For discussion  
on 28 February 2003

**Legislative Council Panel on Transport**  
**Supplementary Information on**  
**Noise Barriers at Widening of Tolo Highway**  
**Section between Ma Liu Shui Interchange**  
**and Island House Interchange**

### Widening of Tolo Highway Section between Island House Interchange and Ma Liu Shui Interchange

圖三 在大埔39區的隔音屏障  
 PLAN C - NOISE BARRIERS AT TAI PO AREA 39

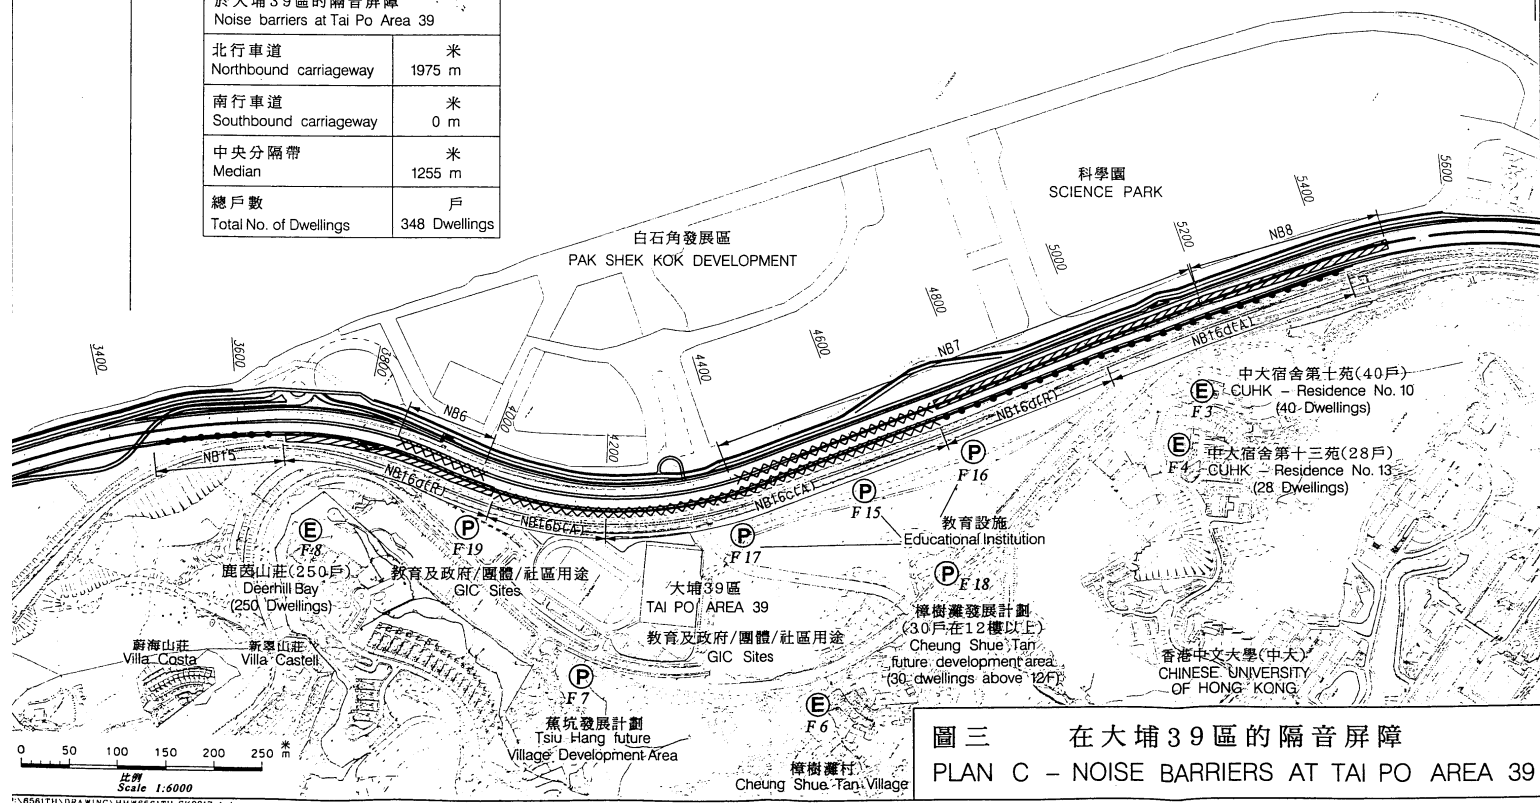
於大埔39區的隔音屏障 Noise barriers at Tai Po Area 39	
北行車道 Northbound carriageway	1975 米 m
南行車道 Southbound carriageway	0 米 m
中央分隔帶 Median	1255 米 m
總戶數 Total No. of Dwellings	348 戶 Dwellings

圖四 在吐露港公路南段的隔音屏障  
PLAN D - NOISE BARRIERS AT SOUTHERN SECTION  
OF TOLO HIGHWAY

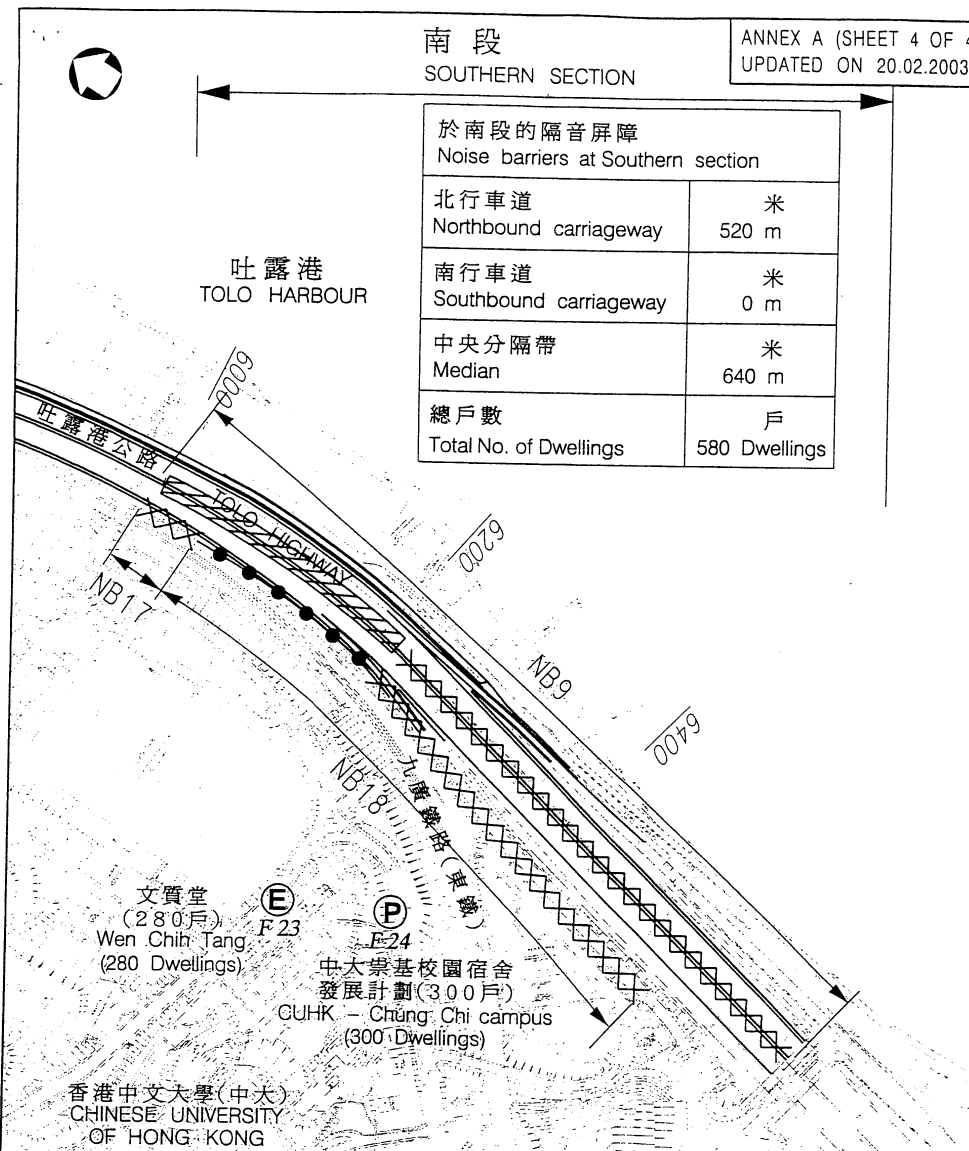
於南段的隔音屏障 Noise barriers at Southern section	
北行車道 Northbound carriageway	520 米
南行車道 Southbound carriageway	0 米
中央分隔帶 Median	640 米
總戶數 Total No. of Dwellings	580 Dwellings
